# Access Compliance Report

## Public Rights-of-Way

Intersection ID: 52839	Main Street: DOCIA_CROSSING_RD	Cross Street: ROBERT_HELMS_RD	Location: SW
ADA ID: 35C1AD5B7D41	Ramp Type: Perp	Initial Pass/Fail: Fail	Overall Compliance: No
Severity Score: 21.25			
Codes/Mitigation Info/Possible Solution		Field Measurements/Component Compliance

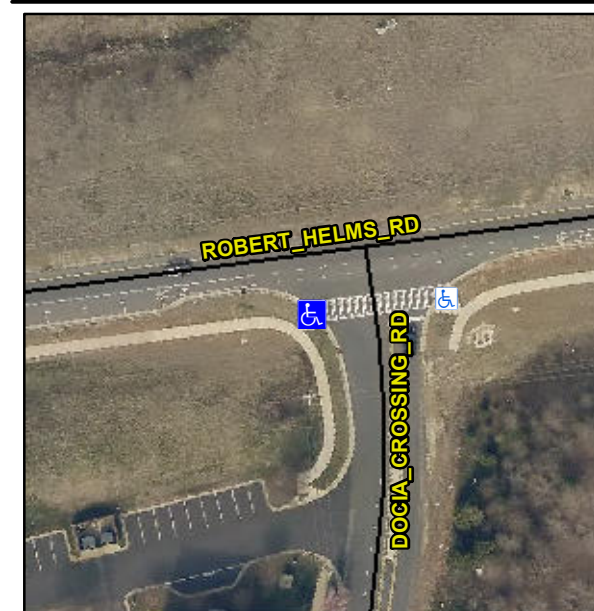
**R304.5.1, R304.5.3**

Compliance	Description	Data	Compliance	Description	Data
N/A	Ramp Length (in)	116.0	Yes	Ramp Slope (%)	7.5
No	Ramp Width (in)	40.0	No	Ramp XSlope (%)	6.5
N/A	Flare Type LT	N/A	N/A	Flare Type RT	N/A
N/A	Flare Slope LT (%)	N/A	N/A	Flare Slope RT (%)	N/A
N/A	Flare Traversable LT?	N/A	N/A	Flare Traversable RT?	N/A
N/A	Landing Length (in)	N/A	N/A	DWS Provided?	N/A
N/A	Landing Width (in)	N/A	N/A	DWS Contrast?	N/A
N/A	Landing Slope (%)	N/A	N/A	DWS Length (in)	N/A
N/A	Landing X Slope (%)	N/A	N/A	DWS Full Width?	N/A
N/A	Landing Curb? (Y/N)	N/A	N/A	DWS Offset (in)	N/A
N/A	Shared Landing?	N/A			
N/A	Gutter Ponding?	N/A	N/A	Gutter Slope (%)	N/A
N/A	Gutter Lip Ht (in)	N/A	N/A	Gutter X Slope (%)	N/A
N/A	Painted X Walk1?	Yes	N/A	Painted X Walk2?	N/A
	X Walk 1 Direction	To E		X Walk 2 Direction	N/A
N/A	X Walk 1 Width (in)	112.5	N/A	X Walk 2 Width (in)	N/A
	X Walk 1 Slope (%)	1.4		X Walk 2 Slope (%)	N/A
	X Walk 1 X Slope (%)	4.9		X Walk 2 X Slope (%)	N/A

**Remove & Replace Entire Ramp.**
